PROJECT NAME
Alpine Street Garage

PROJECT ADDRESS
11-15 ALPINE STREET
SOMERVILLE, MA

REVISION TO ZBA 2016-75
September 16, 2021

List of Changes; Refer to Accompanying Narrative.

A-104

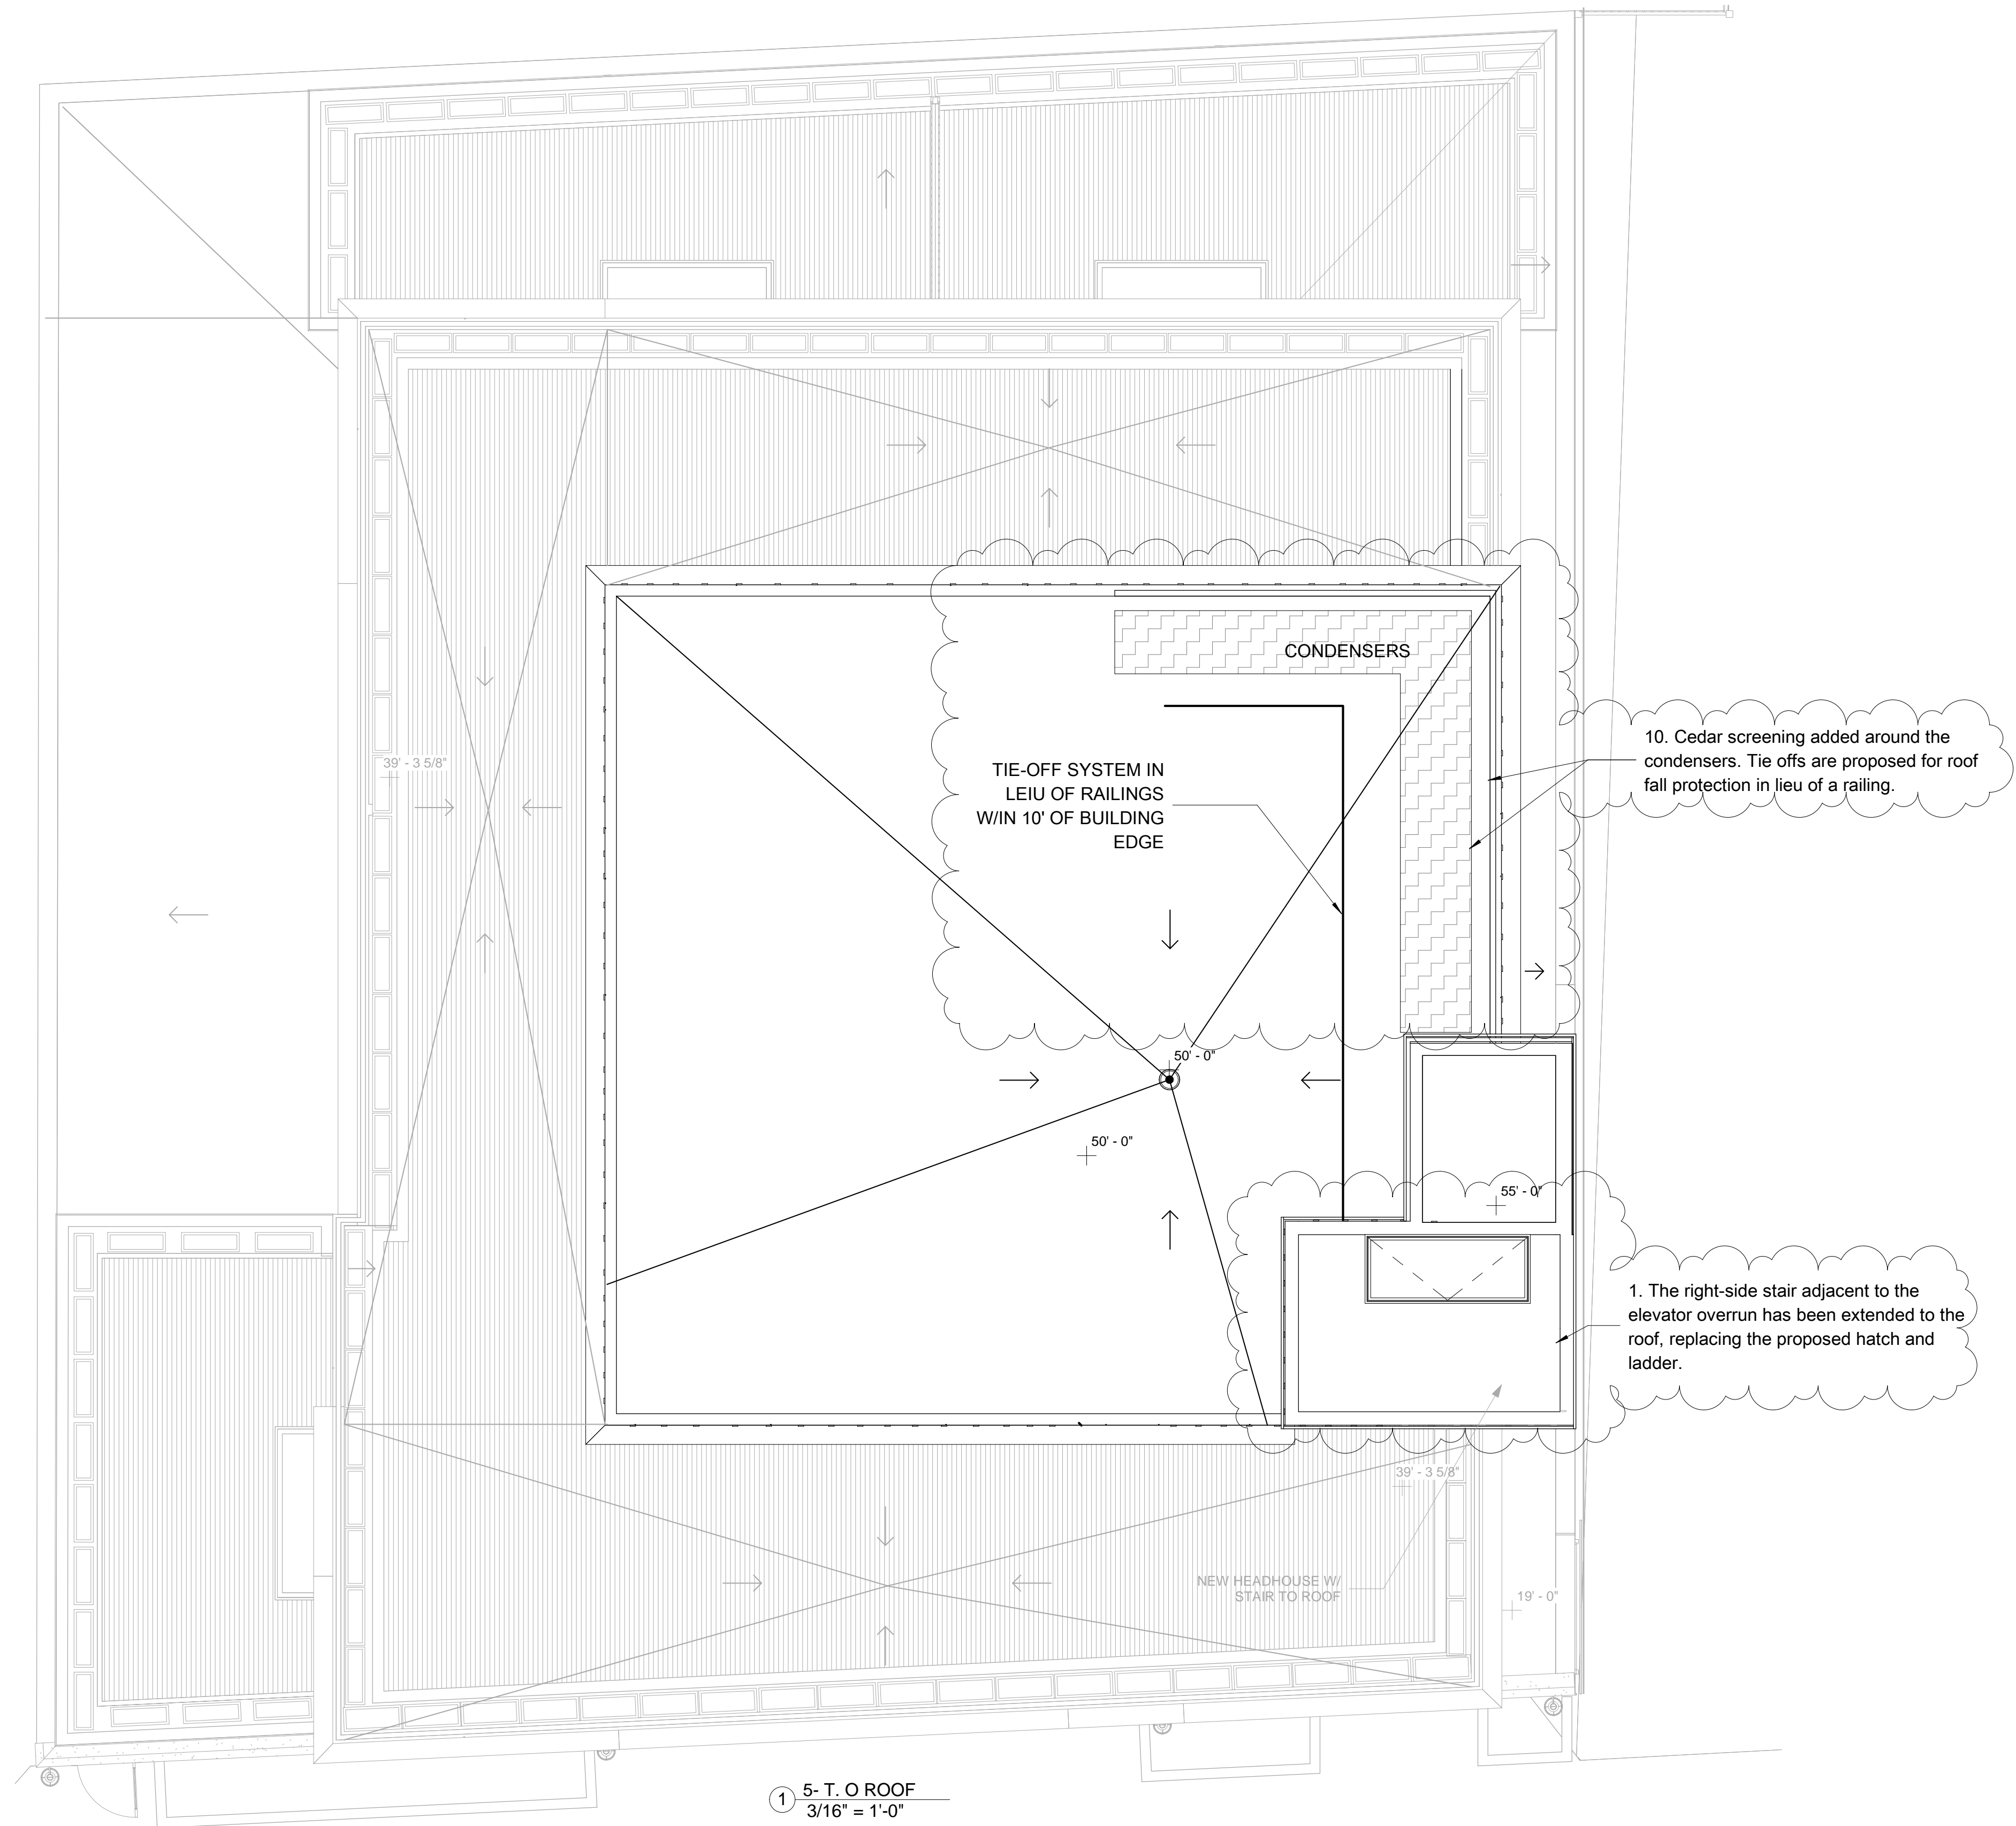
1. The right-side elevation staircase overrun on the roof, which is adjacent to the rooftop elevator overrun, has been extended to match the height of said adjacent elevator overrun.
2. The batten pattern at the top floor and right-side stair tower has been adjusted.
3. New cast stone signage at the center of the front façade is now proposed to read "13 Alpine Street".
4. The veneer at the front wall headers and columns is to be changed to cast stone (Arriscraft or Similar).
5. CMU block is to be used on the Easterly wall.
6. The door and window pattern at the front left side ground floor space has been altered as shown in the elevations.
7. The windows have been slightly altered on all facades as shown in the elevations.
8. The front wall has been replaced as shown in the elevations.
9. The iron railings are to be horizontal.

10. Cedar screening of the rooftop mechanicals with safety tie-offs are being proposed as shown.
11. The wood decking is being extended to three sides of Unit 401 on the 3rd floor roof (a/k/a the fourth floor deck), thereby creating a larger balcony. Additional planters and florals are being proposed to help create a bee habitat. Three options are being proposed:

- A. Mount the railing on top of the parapet wall and construct a raised planter at the inside of the railing, or
 - B. Place the railing inside of the parapet wall on the deck and place planters on the parapet wall up to railing height to address neighbor's privacy concerns, or

- C. Place railing inside of the parapet wall on the deck and place planters inside of the railings on the deck
12. Cast concrete planters at the front of the building on the ground floor are being proposed.

13. The size and spacing of the planters have been altered on all facades as shown.
14. The second floor deck at Unit 201 has been reduced in size.
15. The rooftop HVAC units have been located on the roof, near the roof edge.

A-300

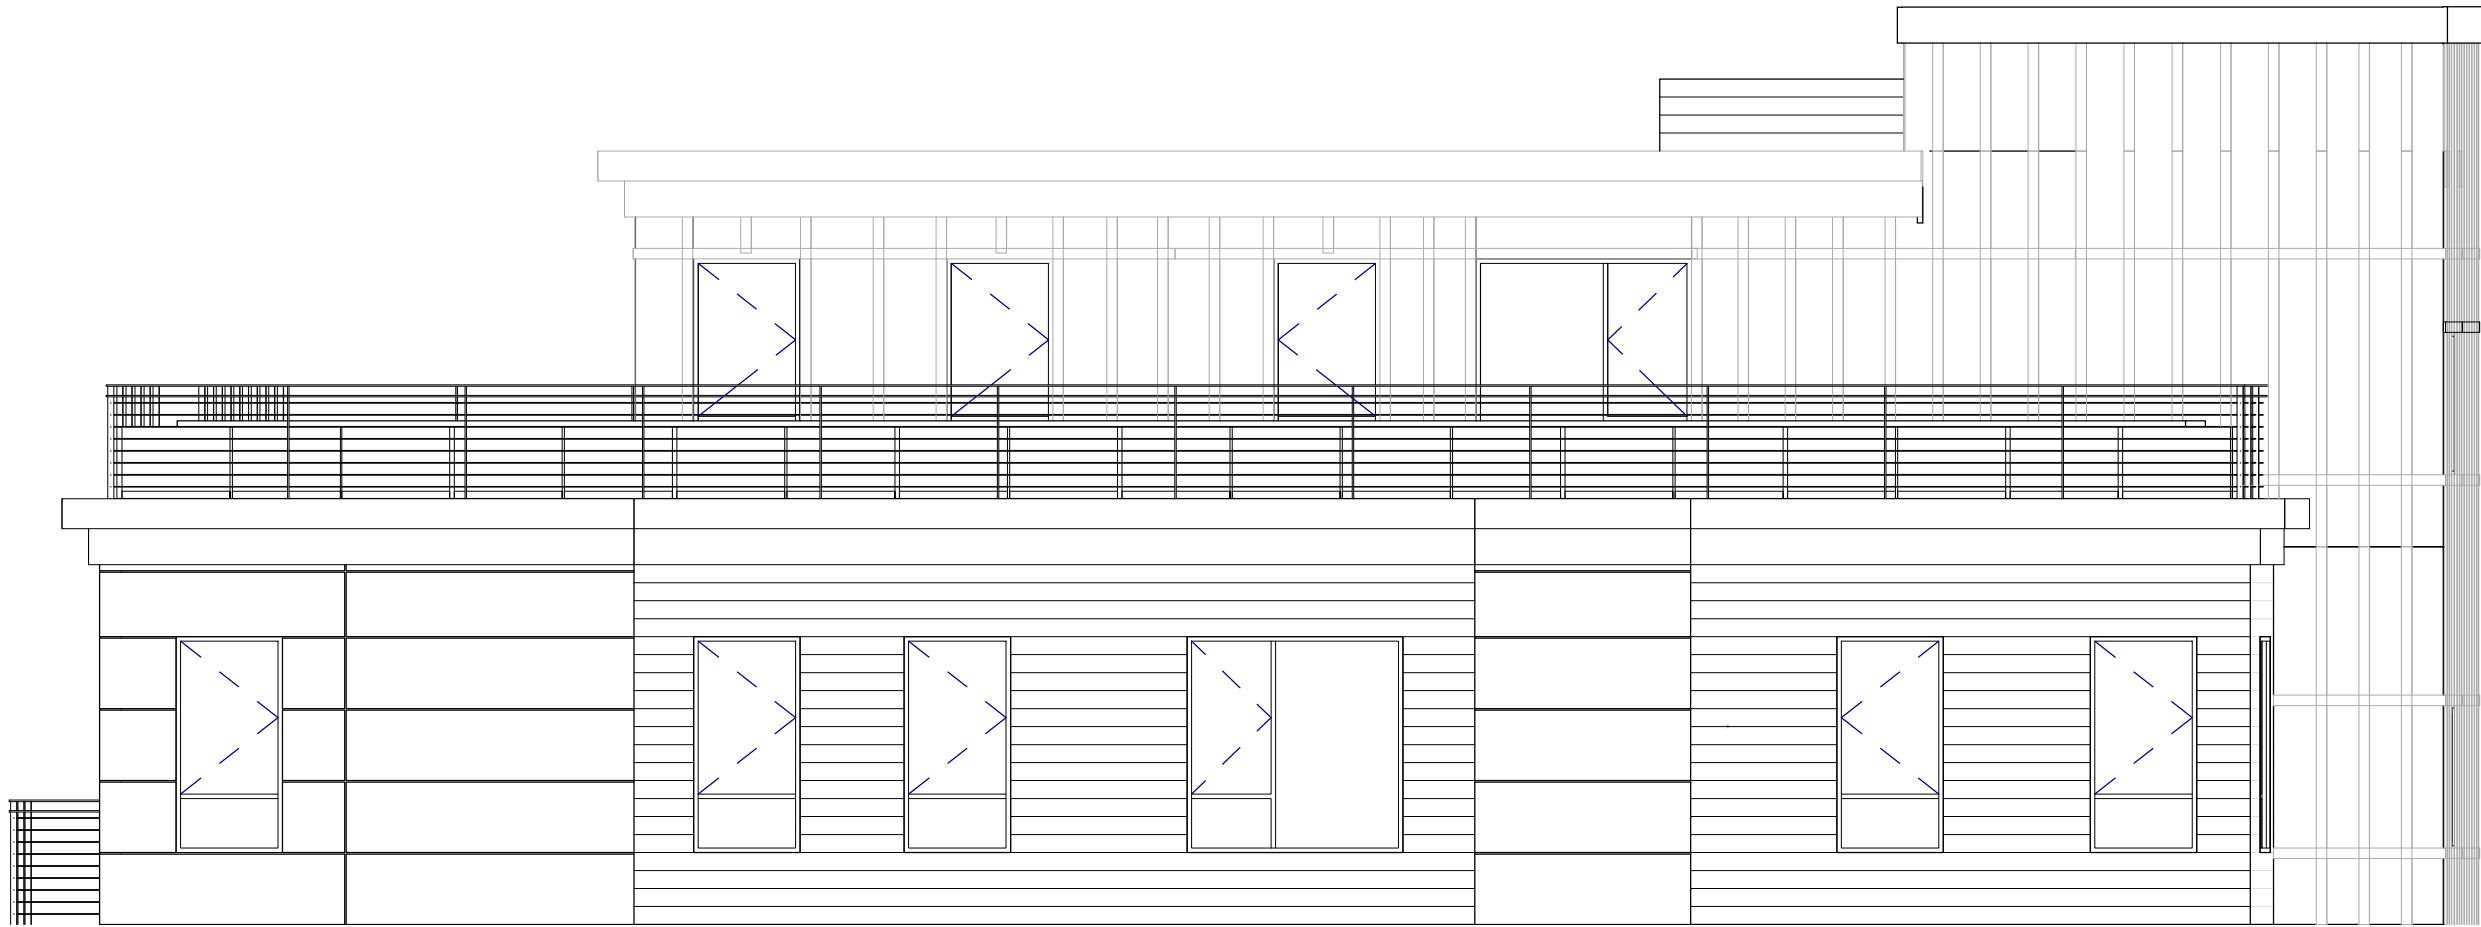
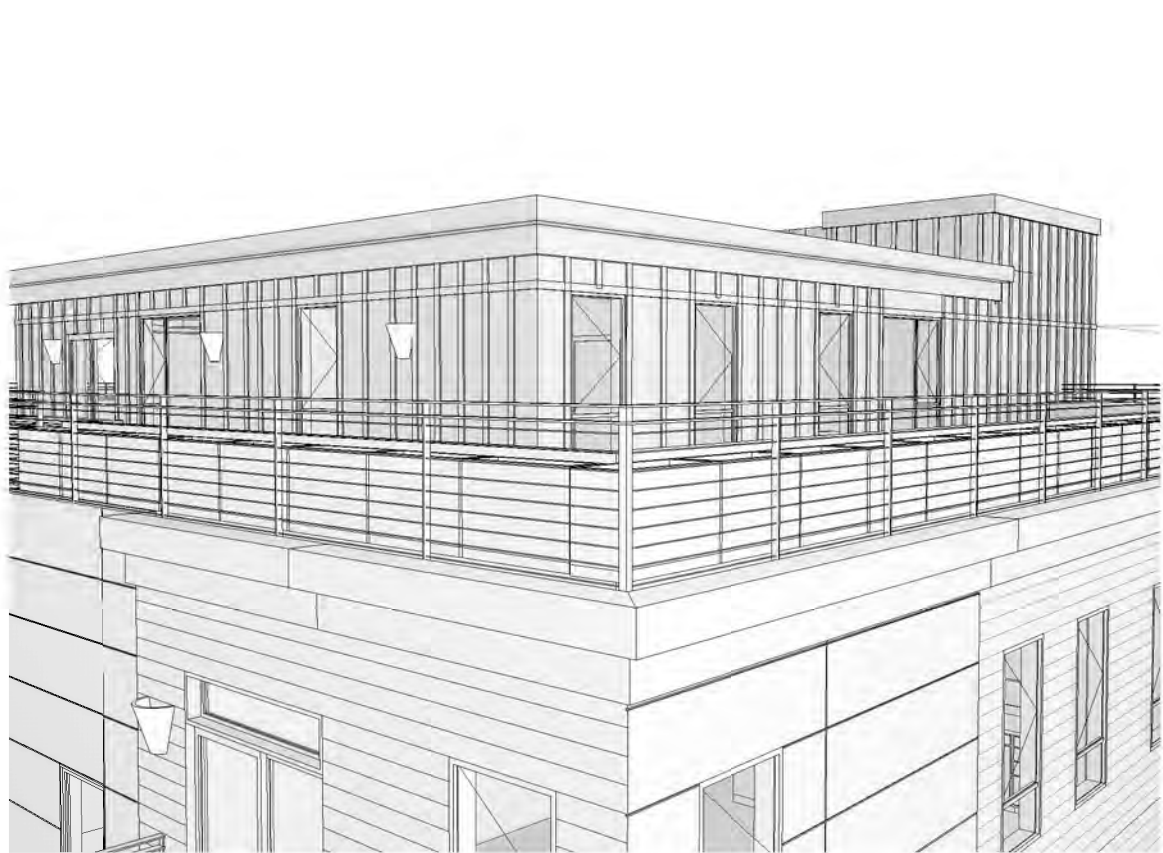
1. The right-side elevation staircase overrun on the roof, which is adjacent to the rooftop elevator overrun, has been extended to match the height of said adjacent elevator overrun.

2. The batten pattern at the top floor and right-side stair tower has been adjusted.
11. The wood decking is being extended to three sides of Unit 401 on the 3rd floor roof (a/k/a the fourth floor deck), thereby creating a larger balcony. Additional planters and florals are being proposed to help create a bee habitat. Three options are being proposed: RE: A-300B

9. The iron railings are to be horizontal.
3. New cast stone signage at the center of the front façade is now proposed to read "13 Alpine Street".
4. The veneer at the front wall headers and columns is to be changed to cast stone (Arriscraft or Similar).

8. The front wall has been replaced.
12. Cast concrete planters at the front of the building on the ground floor are being proposed.
6. The door and window pattern at the front left side ground floor space has been altered as shown in the elevations.
